HOPE CREEK GENERATING STATION
DOCKET NO. 50-354
FSAR CHANGES RESULTING FROM LICENSEE QUALIFICATIONS BRANCH
MEETING JULY 23, 24, AND 25, 1984

Attached are copies of the modifications to FSAR Chapter 13
and Section 1.10, listed below.

HOPE CREEK
GENERATING STATION
FINAL SAFETY ANALYSIS REPORT

FIGURE 13.1 - 9

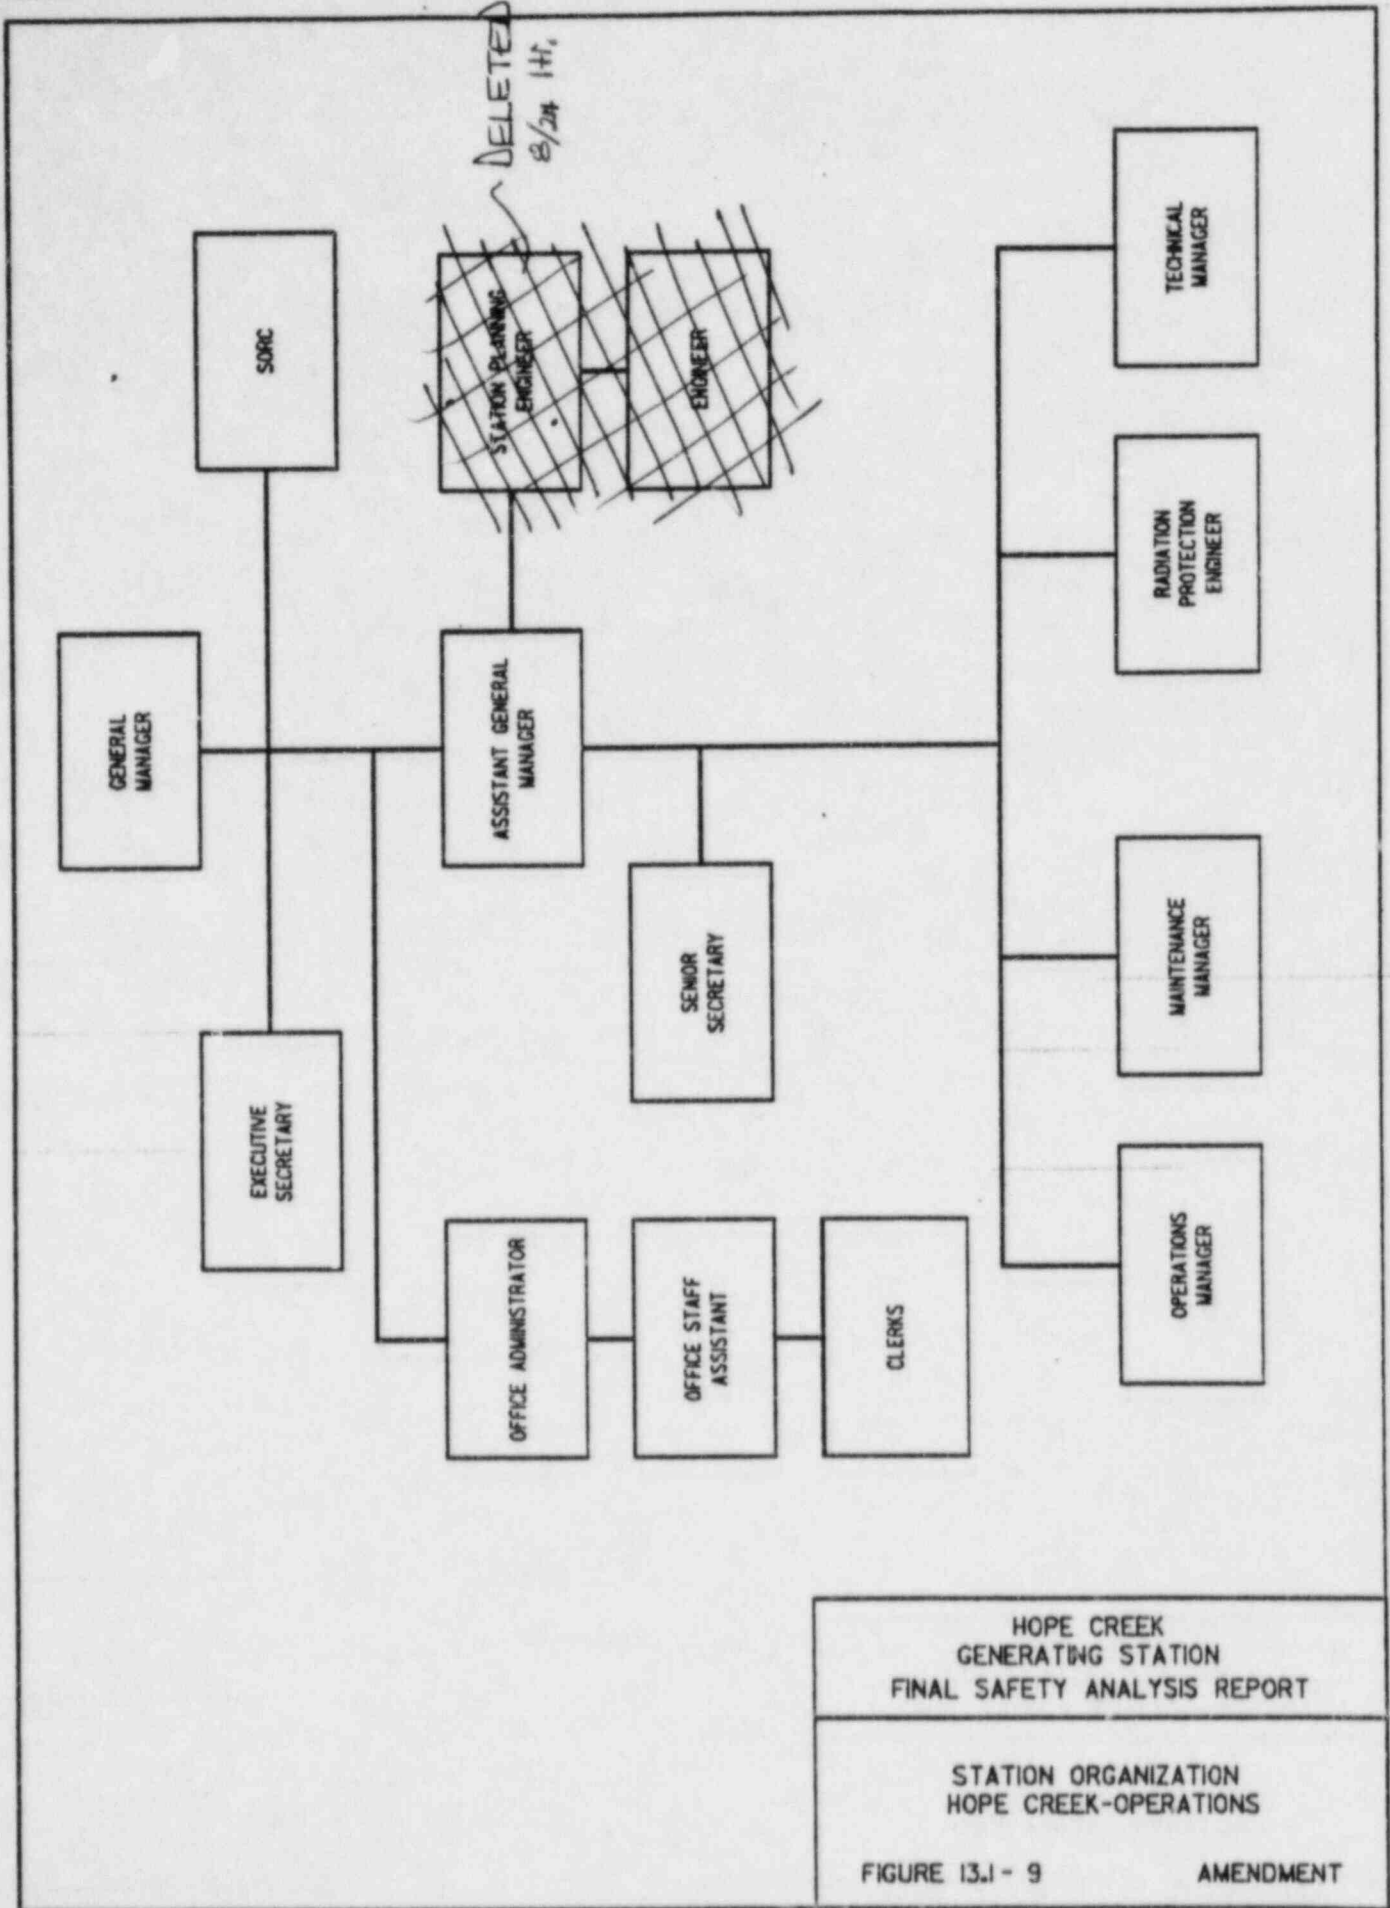
- 1) Correction to FSAR Figure 13.1-9 submitted previously (letter from R. L. Mittl, PSE&G, to A. Schwencer, NRC, dated August 3, 1984).
- 2) Revision to FSAR Page 1.10-21, TMI item I.C.6 which was submitted previously on aforementioned letter. (This revision is in response to a telecon with F. Allenspach, NRC Licensee Qualifications Branch).

- 1) Correction to FSAR Figure 13.1-9 submitted previously (letter from R. L. Mittl, PSE&G to A. Schwencer, NRC, dated August 3, 1984).
- 2) Revision to FSAR Page 1.10-21, TMI item I.C.6 which was submitted previously on aforementioned letter. (This revision is in response to a telecon with F. Allenspach, NRC Licensee Qualifications Branch).
- 3) Resubmittal of modifications to FSAR Chapter 13 and Section 1.10 discussed at the NRC/PSE&G Licensee Qualifications Branch meeting held July 23, 24 and 25, 1984, previously submitted via letter from R. L. Mittl, PSE&G, to A. Schwencer, NRC, dated August 3, 1984.

HOPE CREEK
GENERATING STATION
FINAL SAFETY ANALYSIS REPORT
ENGINEERING AND CONSTRUCTION
DEPARTMENT
ENGINEERING DEPARTMENT
FIGURE 13.1-4

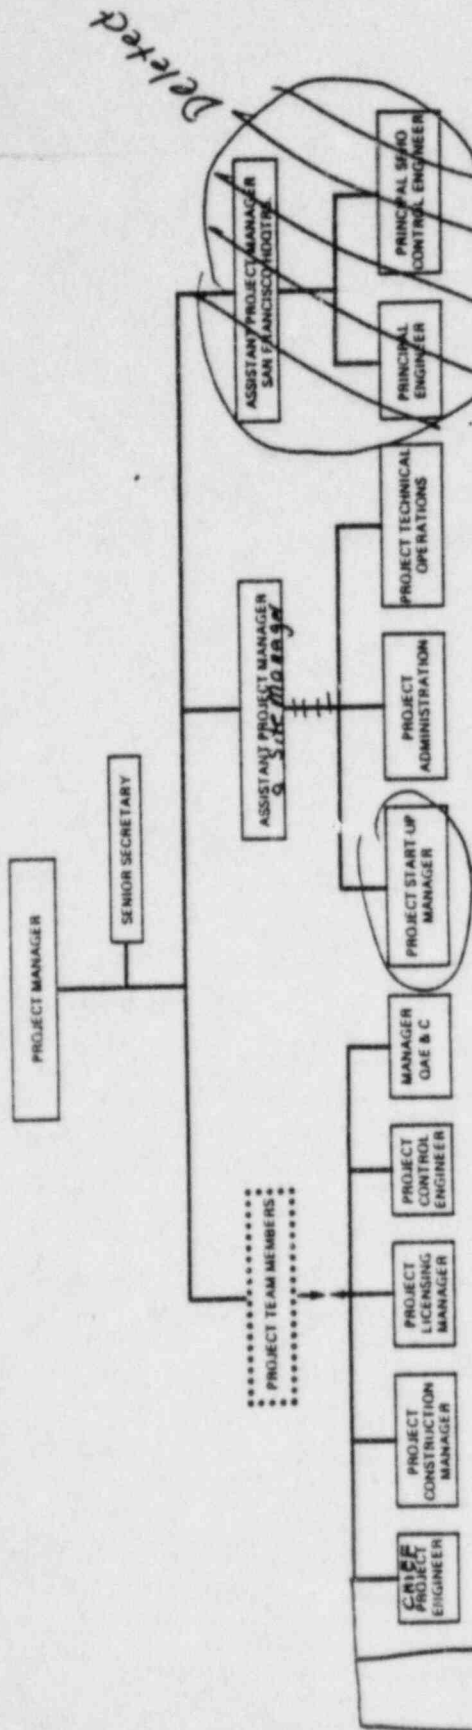
*Deleted- Project Start-up
 Manager Reports to the
 GM- construction, E&C Dept
 and is Matixed to AM-HC
 QS indicated*
